MIL-B-24535(SH)
 AMENDMENT-2
 29 December 1978
 SUPERSEDING
 AMENDMENT-1
 8 August 1977

BURNER, CARBON MONOXIDE AND HYDROGEN, CATALYTIC TYPE (MARK V)

This amendment forms a part of Military Specification MIL-B-24535(SH), dated 6 April 1976 and is approved for use by the Naval Sea Systems Command and is available for use by all Departments and Agencies of the Department of Defense.

FIGURE 1. Weight, overall dimensions, and mount location.

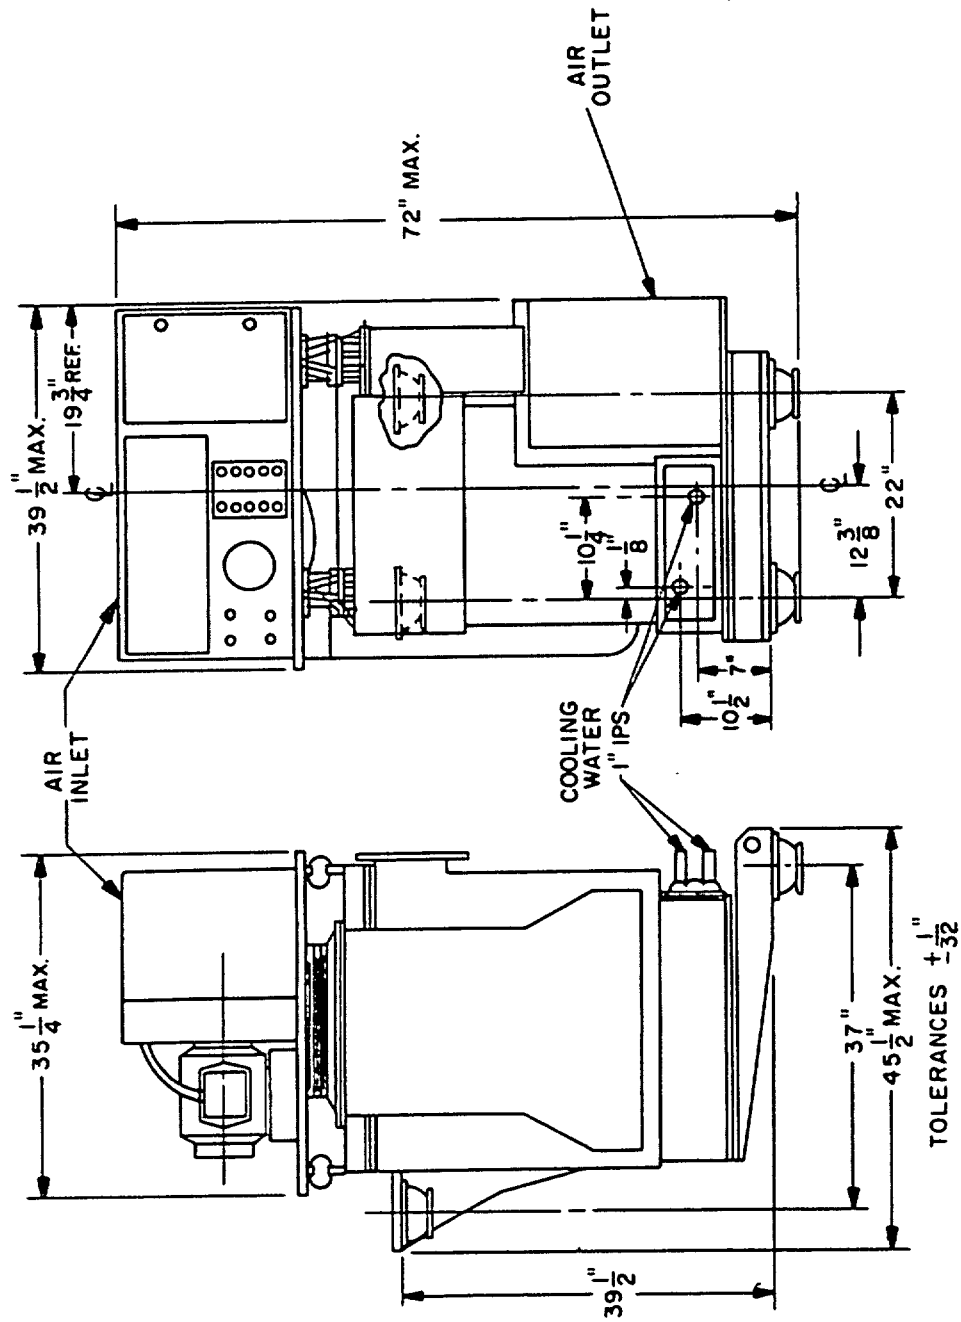
Figure 1: Delete and substitute the attached figure 1.

FIGURE 2. Structureborne noise acceptance criteria.

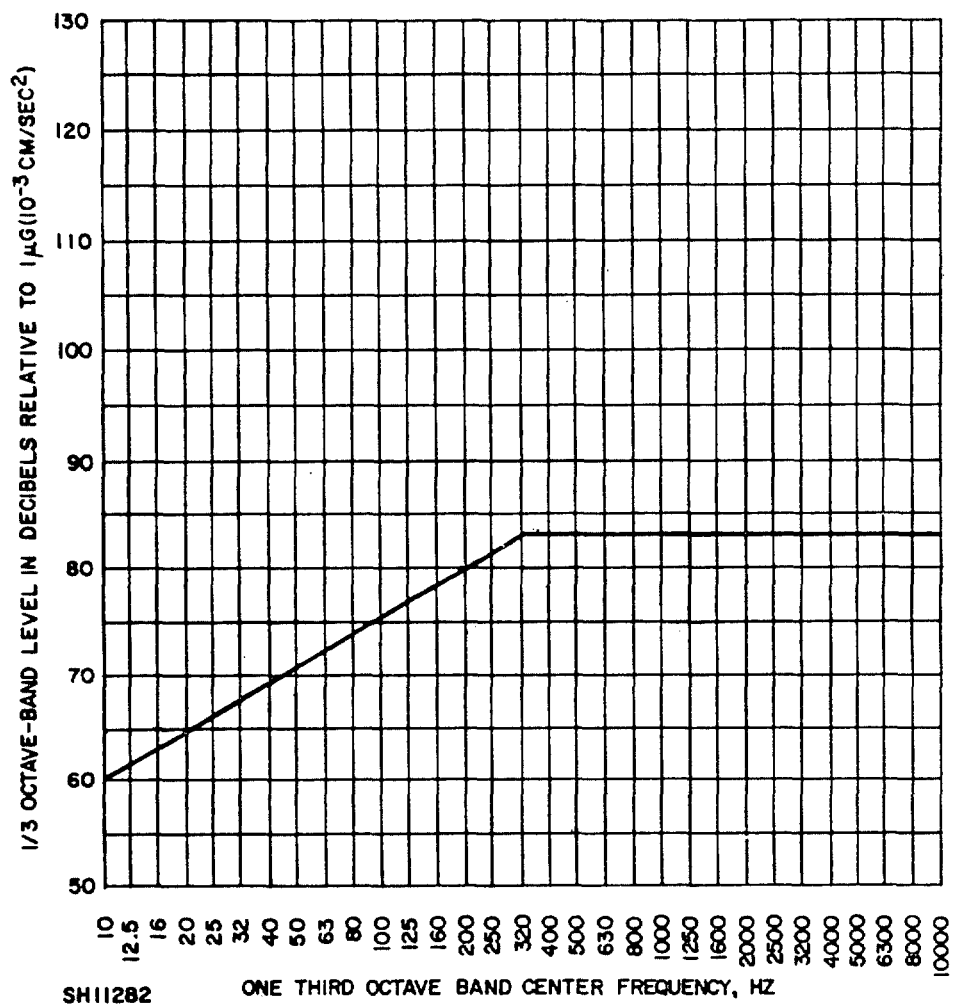
Figure 2: Delete and substitute the attached figure 2.
